FOUNDATION and BEAMS

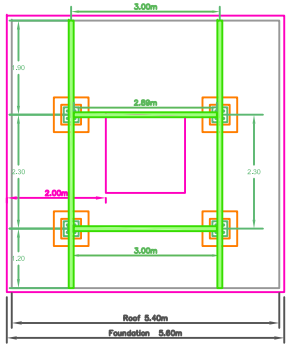
Foundation design requires modification to consider 2 story defensive positions, intermediate floor between 1st and 2nd story, and top roof (6 meters high). Contractor shall submit certified design to COR prior order material and start construction. Design shall be certify by structural engineer.

Cut C - C'

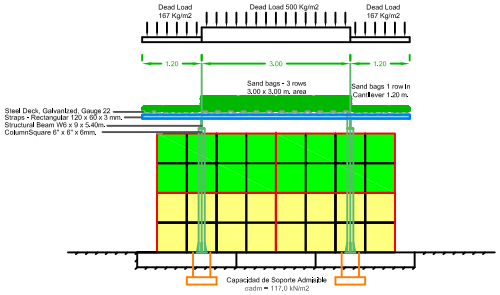
Design requires modification to consider 2 story defensive positions (6 meters high)
